ADDRESSEES	: Owners and operators of vehicles mentioned under “Application” ABC Customer Care and Parts Source
VEHICLE TYPE	: CX45 MY2023
CONFIGURATION GROUP	: 2.46 Traction engine – Accessory drive
BULLETIN TYPE	: Field change program
DATE	: October 19th, 2023
SUBJECT	: Inspection of automatic belt tensioner base plate fasteners
CONDITIONS	: Refer to chapter "Warranty" further on in this bulletin.

DESCRIPTION:

Figure 1: Location of the fasteners securing the automatic belt tensioner base plate

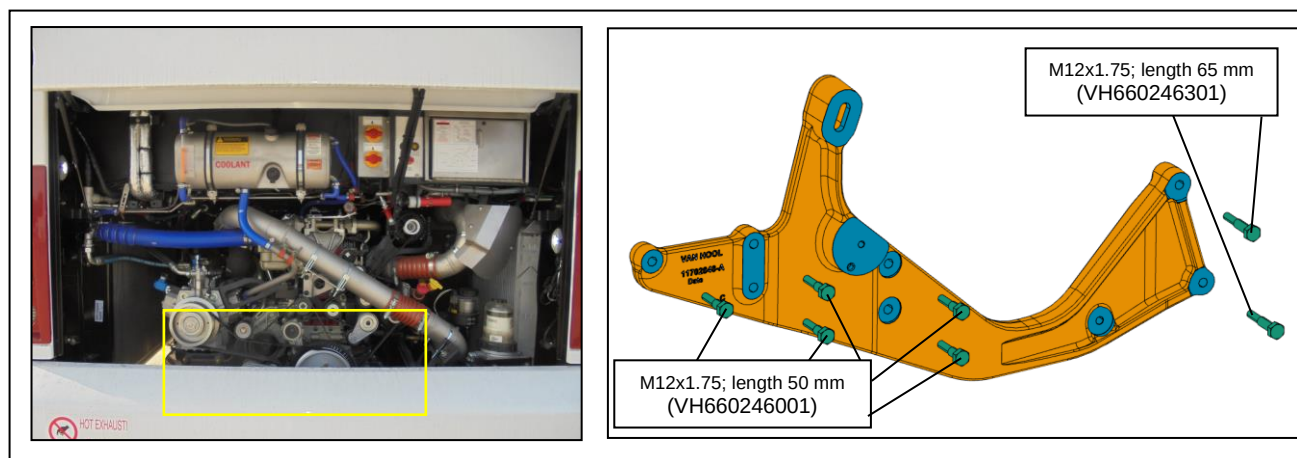
Van Hool has determined that some of the seven fasteners securing the automatic belt tensioner base plate are subject to slackening. Tests have shown that these fasteners must be installed with Loctite 243 and tightened to a torque of 90 ± 10 Nm (65 ± 7 ft.lbf).

To address this issue, Van Hool is conducting a field change program whereby the seven fasteners must be removed and checked one by one for length and thread pitch (1.75 mm). What to do next is explained in this service bulletin.

Step	Action
1	Open the engine compartment rear access door.
2	Remove one of the seven affected fasteners (refer to figure 1).
3	Identify the length and thread pitch of the fastener (refer to figure 1). • If length and thread pitch are okay: clean the thread of the fastener removed. Apply Loctite 243 on the thread and re-install the fastener with a torque of 90 ± 10 Nm (65 ± 7 ft.lbf). • If the thread pitch is okay, but the length is not: take a fastener with the proper length. Clean the thread of the fastener. Apply Loctite 243 on the thread and install the fastener with a torque of 90 ± 10 Nm (65 ± 7 ft.lbf). • If the length is okay, but the thread pitch is not: temporary re-install the 1.5 mm thread pitch fastener with a torque of 90 ± 10 Nm (65 ± 7 ft.lbf) and contact ABC to determine the next step.
4	Repeat steps 2 and 3 for the six other affected fasteners.
5	Close the engine compartment rear access door.
